B2xx, B1 Frontboard, PWB11978

CIRCUIT SCHEMATIC DIAGRAM

ECAD
 SMC
 MECHANICAL DESIGN K GALLICHAN
 BOARD NAME B2XX, B1 Frontboard

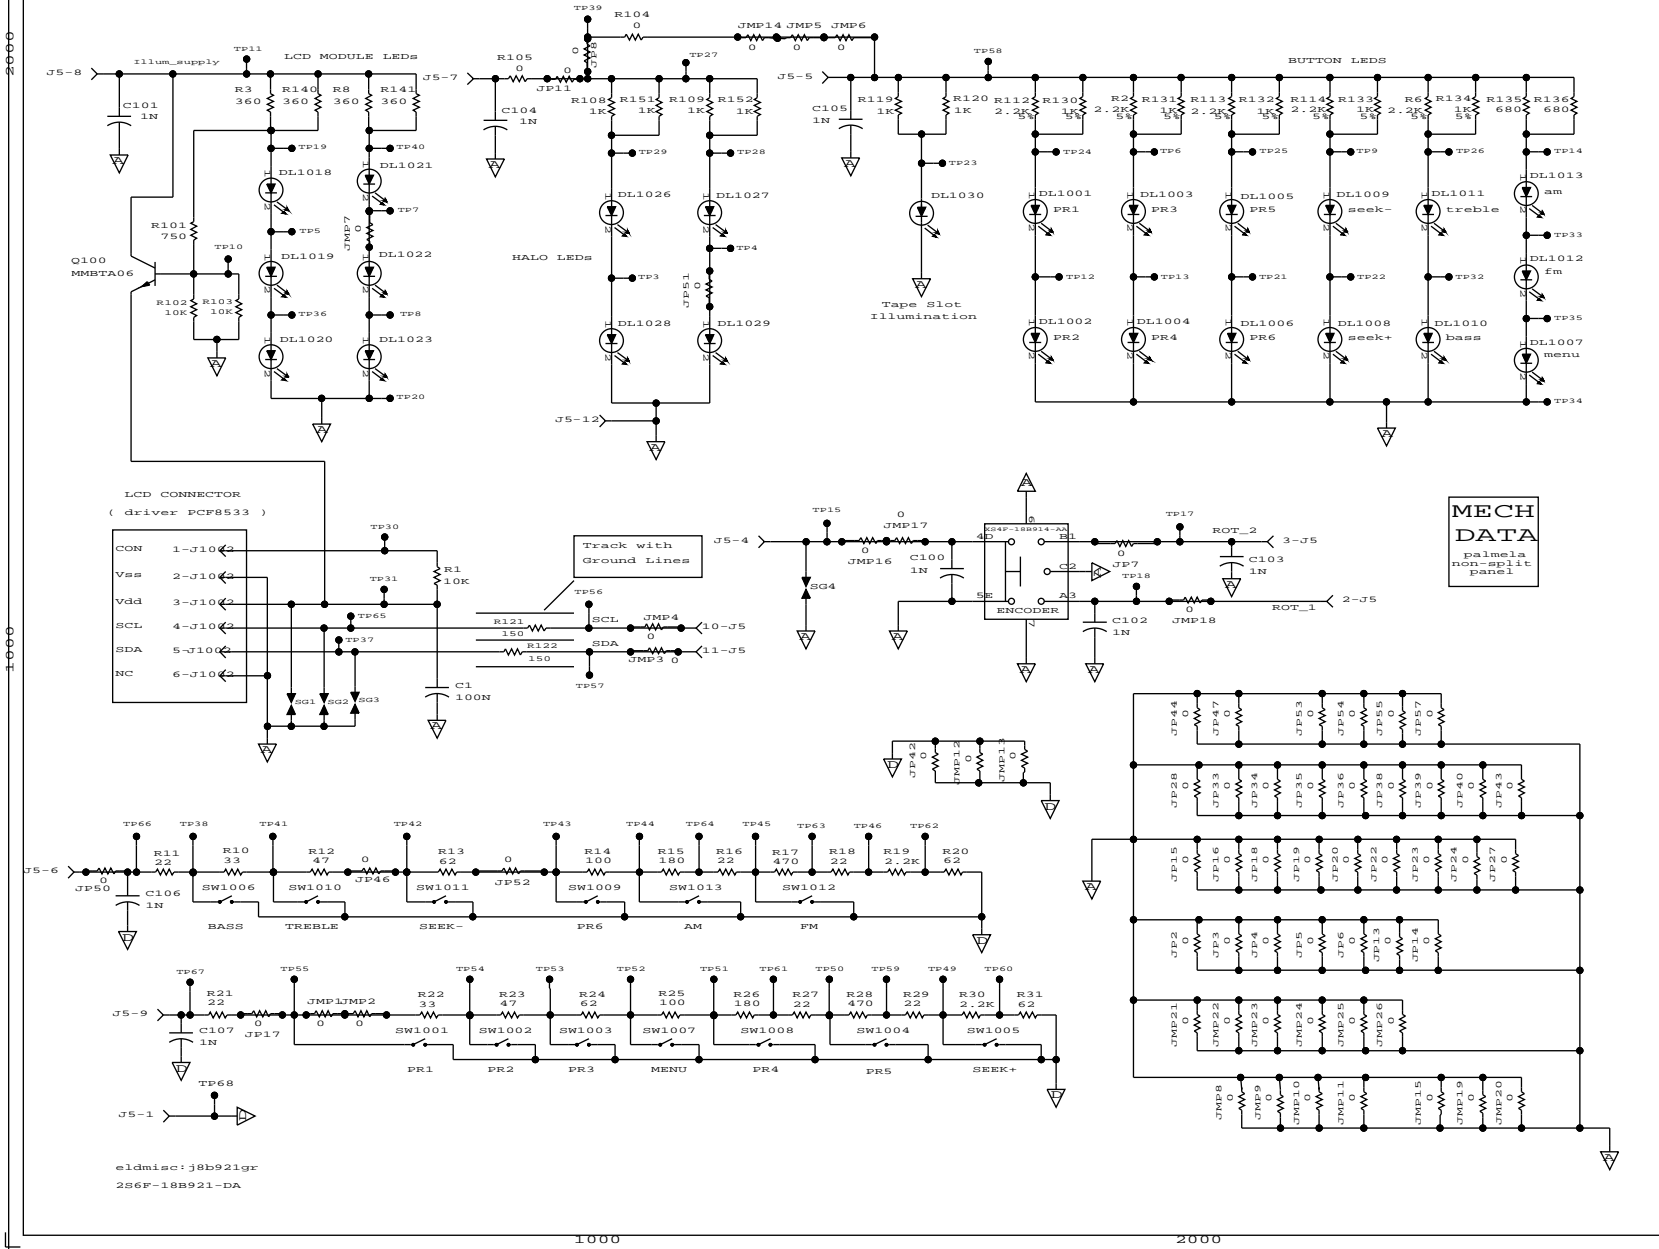
NOV 2002
 Change R3 from 680 to 360
 Change R8 from 680 to 360
 Change R140 from 680 to 360
 Change R141 from 680 to 360
 Add all the jumpers
 Add M_FLEX1 and M_FLEX2

Feb 2003
 Change switches and DL1030 cells

Jun 2003
 Change R2,R6,R112,R113 and R114 from 750 to 2.2k
 Change R130,R131,R132,R133 and R134 from 750 to 1k
